**SUBJECT:** Submission of License Amendment Request, PUR-1, Docket 50-182 – Management Chain Change

This letter is a request to amend the PUR-1 license, Docket 50-182, to change the Organization Chart for Reactor Administration in the PUR-1 Technical Specifications. When reviewing the PUR-1 Safety Analysis Report as dated June 30, 2008 (ML 111890201) and the PUR-1 Technical Specifications as approved on October 31, 2016 (ML16267A001), the Level 1 designee is not consistent. This License Amendment seeks to rectify the issue and utilize an organizational structure to continue the safe operation of the PUR-1. Following consultation with both the Dean of Engineering and Head of the School of Nuclear Engineering, the Head has been selected as the most appropriate choice for the Level 1 designee. The Head has a greater familiarity with the operation of the facility which will result in a more productive dialogue between the Facility Director and the Head.

**Figure 6.1: Organization Chart for Reactor Administration**

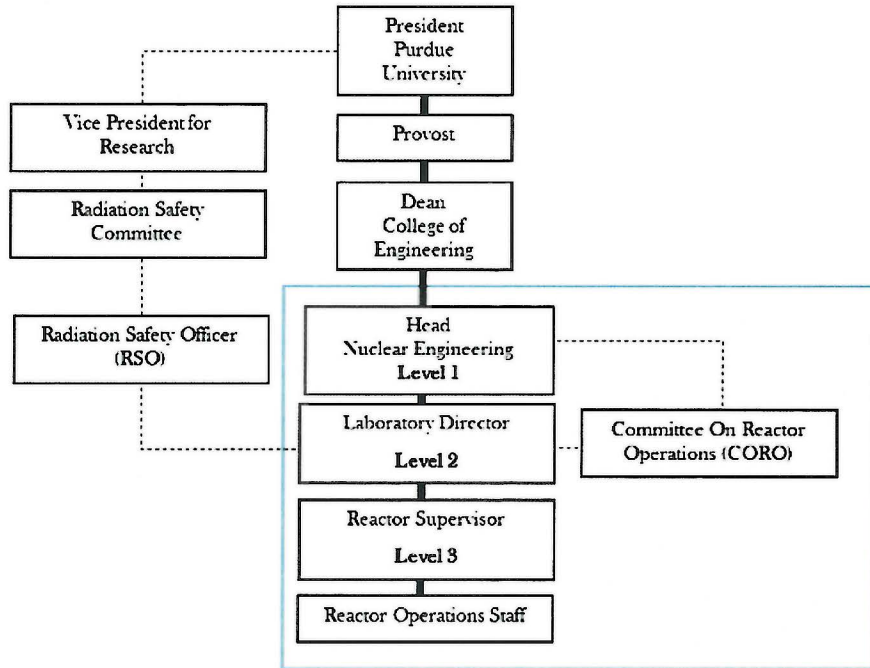
The current head of the School of Nuclear Engineering is Dr. Seungjin Kim, the Laboratory Director is Dr. Robert Bean, and the Reactor Supervisor is Clive Townsend. The Committee On Reactor Operations will continue to be chaired by the RSO and the Head will appoint its other members, maintaining all prior voting requirements. Dr. Kim received his Ph.D. in Nuclear Engineering in 1999 and has extensive research experience.

**Figure 6.1: Organization Chart for Reactor Administration**

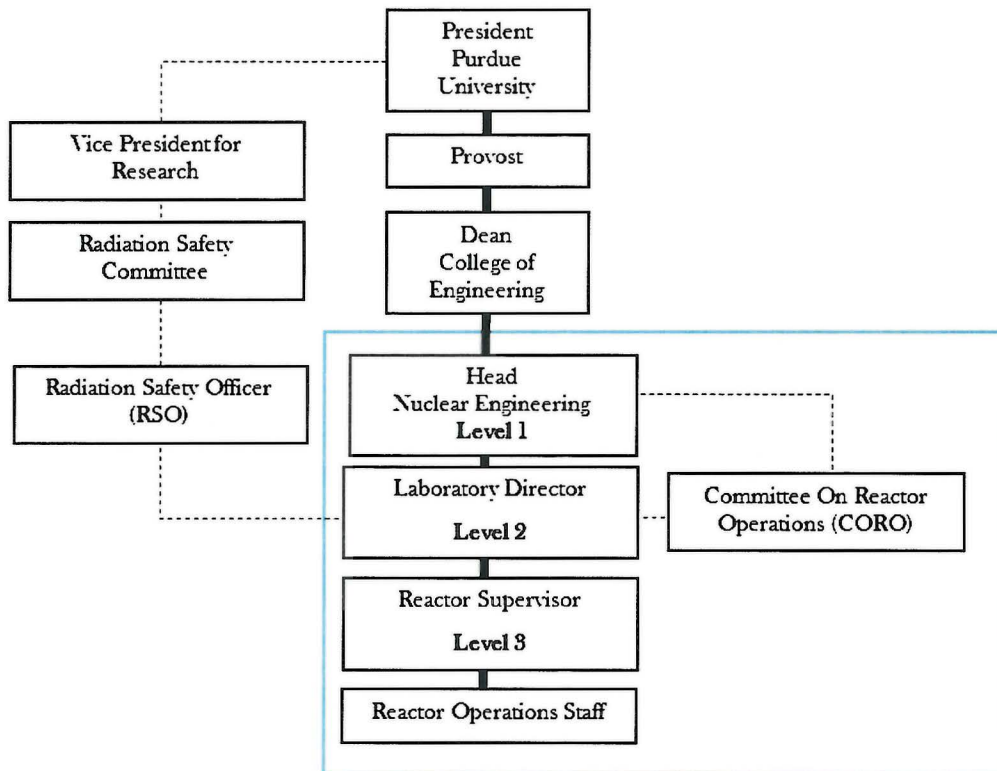
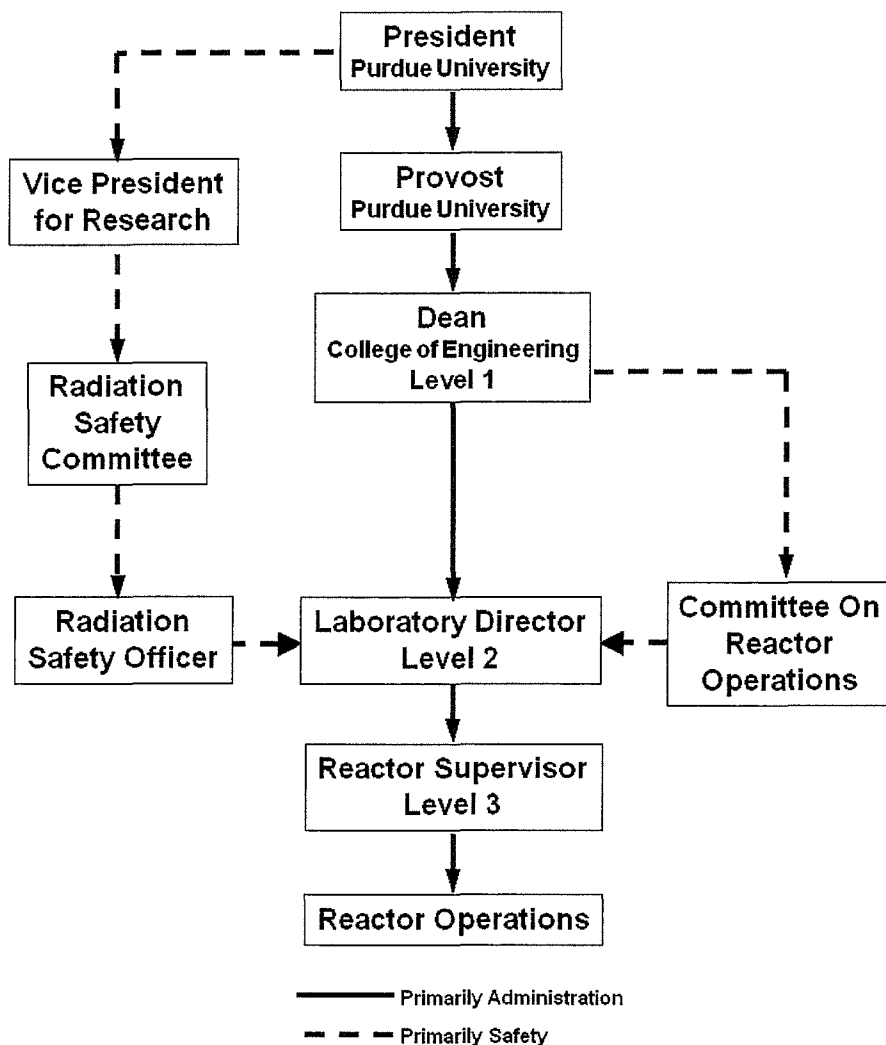
The PUR-1 Facility is managed and run by members of the university's College of Engineering, specifically the School of Nuclear Engineering. ~~The Dean of the College of Engineering~~ The Head of the School of Nuclear Engineering shall be the final authority on all PUR-1 matters. The Laboratory Director is responsible to the ~~Dean-Head~~ for the administration and proper and safe operation of the facility. Figure 6.1 shows the administration chart for the PUR-1. The Committee on Reactor Operations advises the director of the PUR-1 on all matters or policy pertaining to safety. The Radiological Safety Officer provides advice concerning personnel and radiological safety and provides technical assistance and review in the area of radiation protection.

1. A line management organizational structure provides for personnel who shall administrate and operate the reactor facility.
2. The ~~Dean~~ Head and the Facility Director shall have line management responsibility for adhering to the PUR-1 license and Technical Specifications and for safeguarding the public and facility personnel from undue radiation exposure.

- a) Level 1: ~~Dean of the College of Engineering~~Head of the School of Nuclear Engineering: Responsible for the PUR-1.
- b) Level 2: PUR-1 Facility Director: Responsible for reactor facility operation and shall report to Level 1.
- c) Level 3: Reactor Supervisor: Responsible for the day-to-day operation of the PUR-1 including shift operation and shall report to Level 2.
- d) Level 4: Reactor Operating Staff: Licensed reactor operators and senior reactor operators and trainees. These individuals shall report to Level 3.
- e) The reporting structure of Figure 6.1 is such that those personnel below shall report up and those personnel listed above may communicate down.

**Figure 6.1: Organization Chart for Reactor Administration**

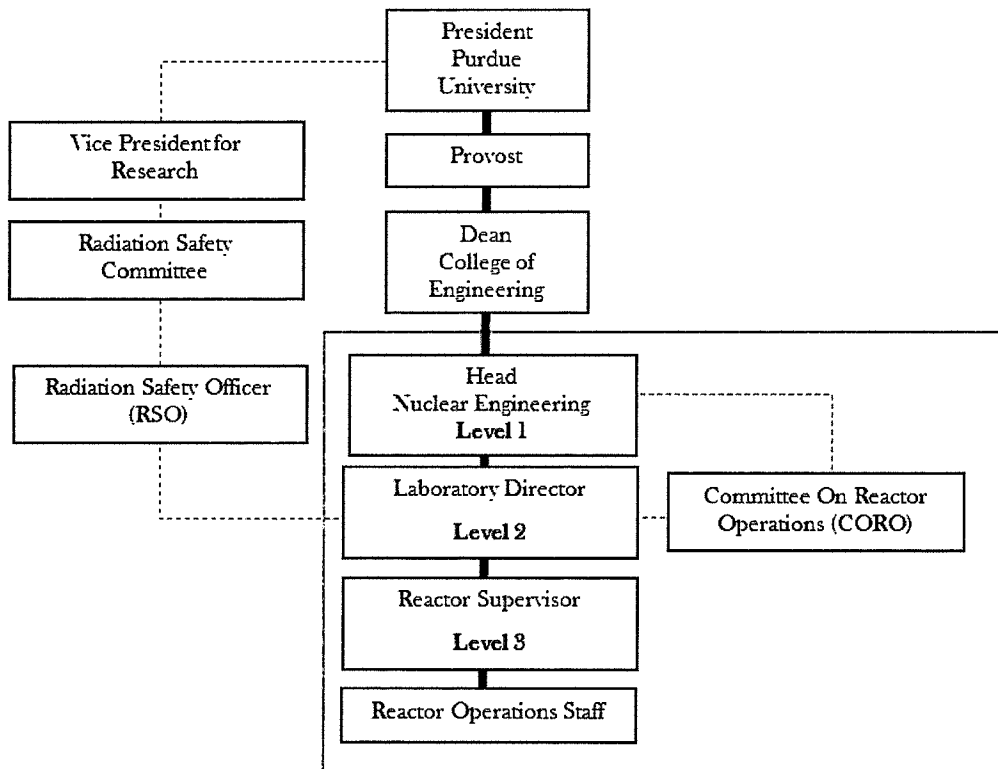
- a) Level 1: Head of the School of Nuclear Engineering: Responsible for the PUR-1.
- b) Level 2: PUR-1 Facility Director: Responsible for reactor facility operation and shall report to Level 1.
- c) Level 3: Reactor Supervisor: Responsible for the day-to-day operation of the PUR-1 including shift operation and shall report to Level 2.
- d) Level 4: Reactor Operating Staff: Licensed reactor operators and senior reactor operators and trainees. These individuals shall report to Level 3.
- e) The reporting structure of Figure 6.1 is such that those personnel below shall report up and those personnel listed above may communicate down.
